RE: ADDITIONAL INFORMATION REGARDING 6 NET ROAD, AVALON

On the 7th of December Northern Beaches Council ('Council') requested additional information with regard to the proposed works on the subject site.

Image 1: North Elevation

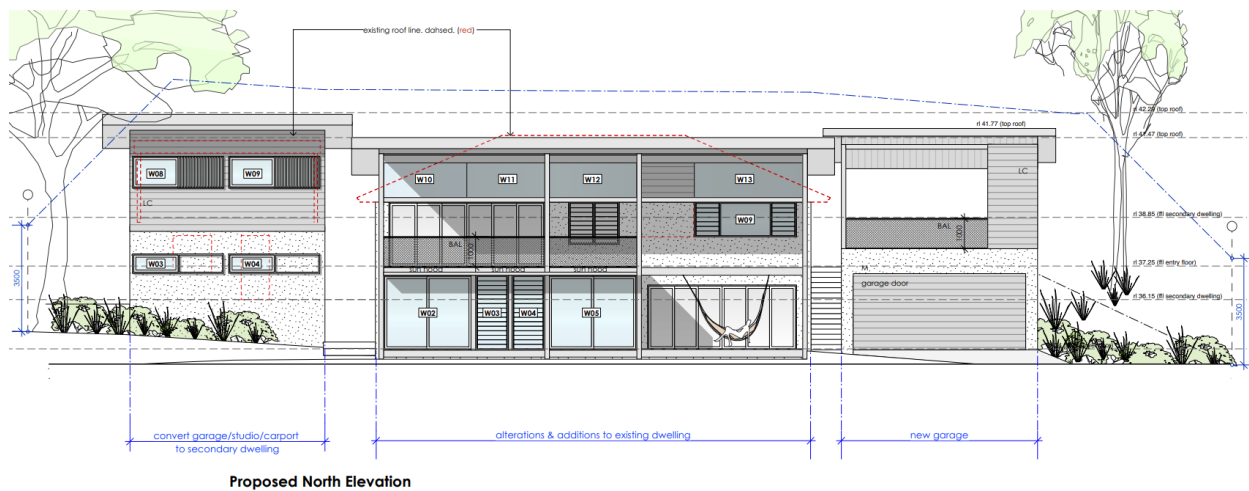
Where the secondary dwelling or rural worker's dwelling is located within, or is attached to the principal dwelling (including the garage) the maximum building height is to be in accordance with the height controls contained within Pittwater Local Environmental Plan 2014.

Response: If the secondary dwelling was attached to the principal dwelling the 2 storey nature would not be an issue. When viewing the north elevation drawing the 3 structures all sit within the 8.5m height and building envelope controls, with the encroachments of eaves being an allowable exception to the envelope control.

The same single storey streetscape presentation would be achieved with a compliant new dwelling or an extension to the existing dwelling. As such, it could not be seen as unreasonable with regard to visual bulk to have a 2 storey secondary dwelling in the proposed location. A development application could propose a new dwelling or an extension to the existing in the same location as the secondary dwelling and result in the same visual bulk within the streetscape and when viewed from adjoining properties.
